# **Certified Action** of the City of Raleigh Planning Commission

Case File / Name: SP-60-10 / Crabtree Place

SP-60-2010 Crabtree Place – Site Plan

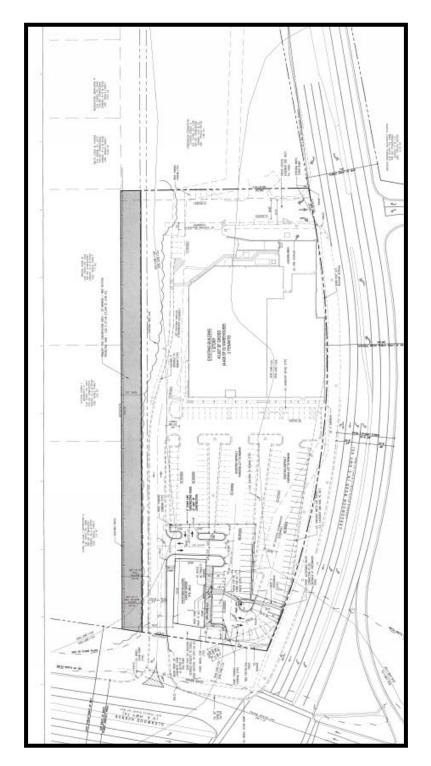
<u>Cc</u>	omment	Response
1.	To soften the visual impact of the unglazed western façade (facing the Brookhaven neighborhood), install evergreen screen plantings, complementarily aligned with vertical breaks in the brick pattern [commensurate with Code Sec. 10- 2132.2(d) (4)].	Additional evergreen plantings in the requested areas have been provided on the updated (2011-05-06) Landscape Plan; we have also proposed some additional ornamental plantings ("Knock-Out" Rose) in front of the building (Glenwood Avenue elevation) to reinforce the design intent of the pedestrian connection to the public sidewalk in Glenwood Avenue right-of-way.

2.	The committee recommends that greater effort be made to create a building more attune to the prominence of the site location. At the least, details found on the other site building (e.g., clerestory windows above storefront glazing, color/ texture of accent wall materials) should be incorporated into the proposed building's design [commensurate with Code Sec. 10- 2132.2(d) (2) & (6)].	<ul> <li>The glass storefronts facing both Creedmoor Road and Glenwood Avenue have been set further behind the engaged columns, and the columns made more substantial in depth to increase architectural detail.</li> <li>A pedestrian door has been added to the Glenwood Avenue (south) elevation.</li> <li>The area of parapet wall above the</li> </ul>
